RE: **Lot 26 Block 6 SAD 228**  
**Volcano Cliffs Subdivision**  
**6209 Papagayo NW**  
**Grading and Drainage Plan**  
**Engineers Stamp Date 7/11/18 (D10D003B26)**  
**CO Certification Dated: 7/23/18**

Based upon the information provided in your submittal received 7/23/18, this plan cannot be approved for Certificate of Occupancy until the following comments are addressed.

ENGINEER'S SEAL	6209 PAPAGAYO ROAD NW	DRAWN BY WCWJ
DAVID SOULE NEW MEXICO REGISTERED PROFESSIONAL ENGINEER	GRADING AND DRAINAGE PLAN	DATE 7-10-18
7/11/18	Rio Grande Engineering 1806 CENTRAL AVENUE SE SUITE 201 ALBUQUERQUE, NM 87106 (505) 872-0999	SHEET # —
DAVID SOULE P.E. #14522		JOB # 21800

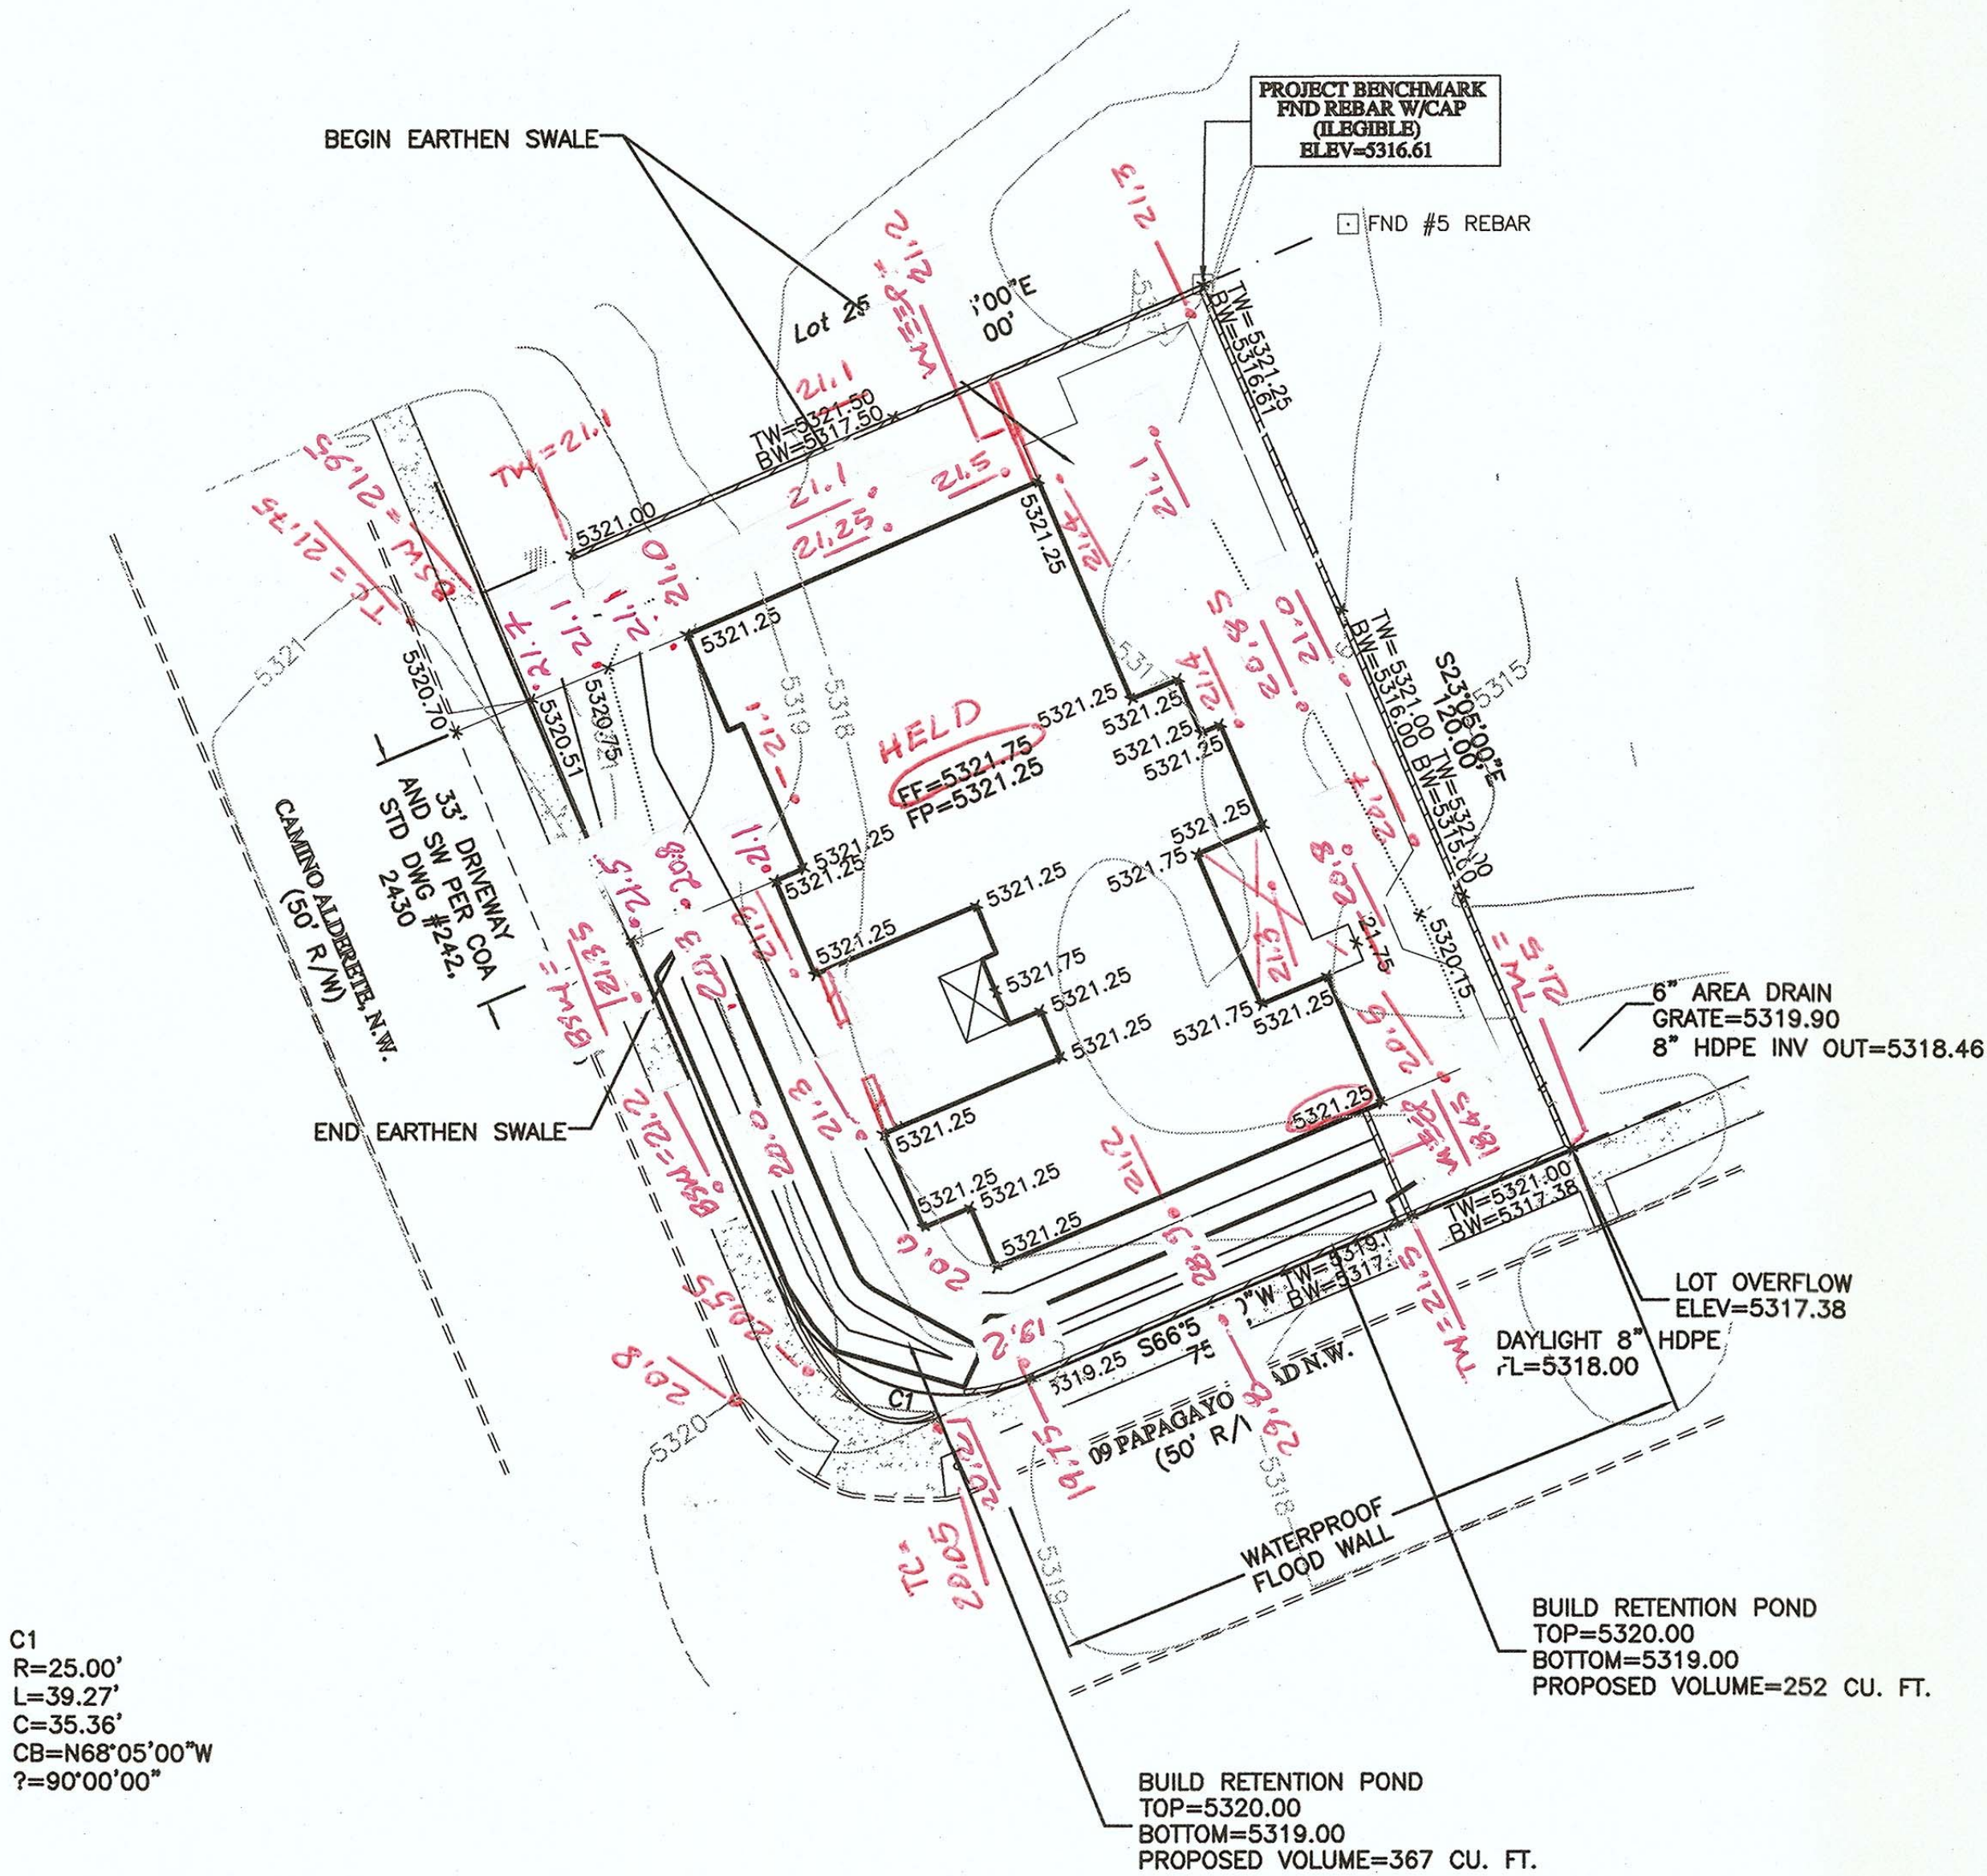
- Remove the concrete slabs on property to the west of this address.
- Remove all concrete and debris in and around the site.
- Remove the dirt in the streets.
- Opening in front yard garden wall is plugged, clear out the dirt.
- Remove the dirt pile in the front yard.
